THM 440-T4 NEW DRIVE CHAIN AND SPROCKETS

COMPLAINT: A new "Rocker-Joint" design drive chain assembly has been released for all 1993 TBM 4T60

Figure 1

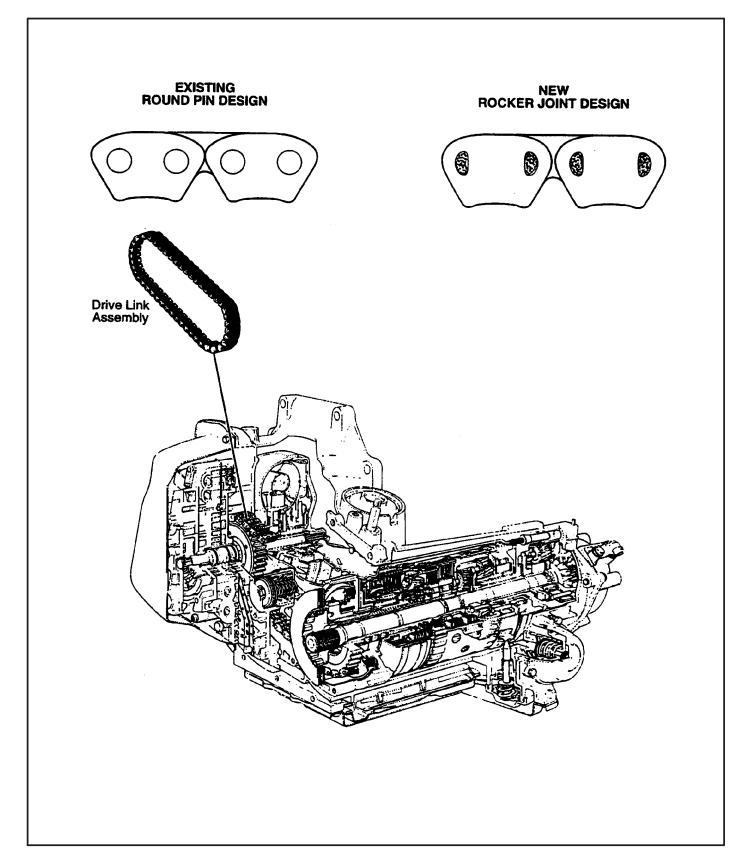
(1) DRIVE CHAIN ASSEMBLY - New "Rocker-Joint" Drive Chain is easily identified by the link pins that are flat on one side. The existing drive chain link pins are round, as shown in Figure 1. Another identification is the color of the master link. The "Rocker-Joint" design are supposed to be copper in color, &, we have seen some of them with black links which is the identification for the existing chain.

USE THE LINK PINS FOR POSITIVE IDENTIFICATION.

Figure 2

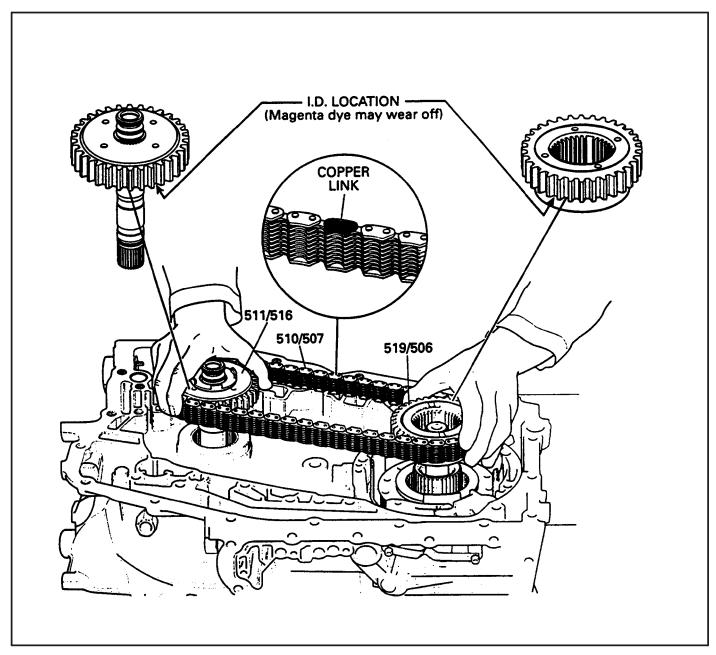
(2) DRIVE SPROCKET ASSEMBLY - It was necessary to change the tooth geometry to accommodate the new "Rocker-Joint" chain and can be identified by the part number stamped on washer surface area in Magenta (Red) ink (See Figure 2)

NOTE: MAGENTA INK MAY WEAR OFF SO USE DIMENSIONS BELOW FOR POSITIVE I.D.

37 TOOTH 4.233" 4.181" APPROX .052" DIFFERENCE 33 TOOTH 3.756" 3.700" APPROX .056" DIFFERENCE

Figure 3

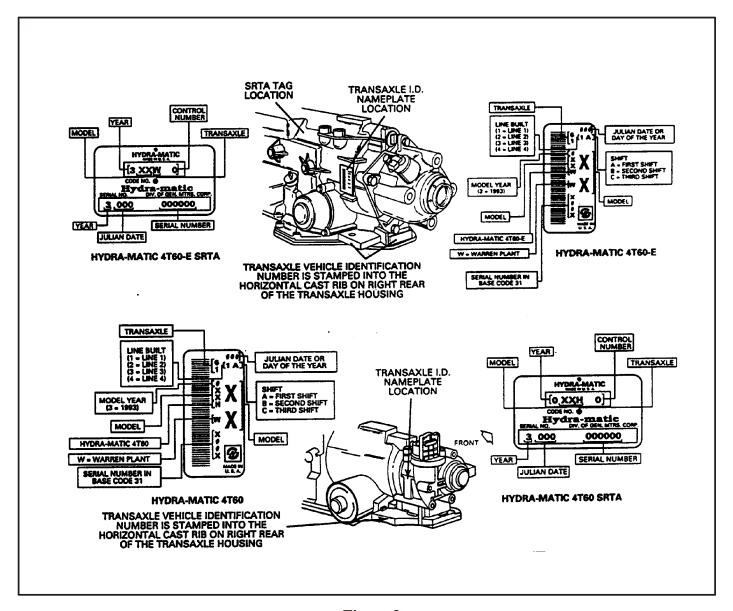
CORRECTION: Refer to Figure 3 for model identification and Julian Date information.

Refer to Figure 3 for model identification and Julian Date.
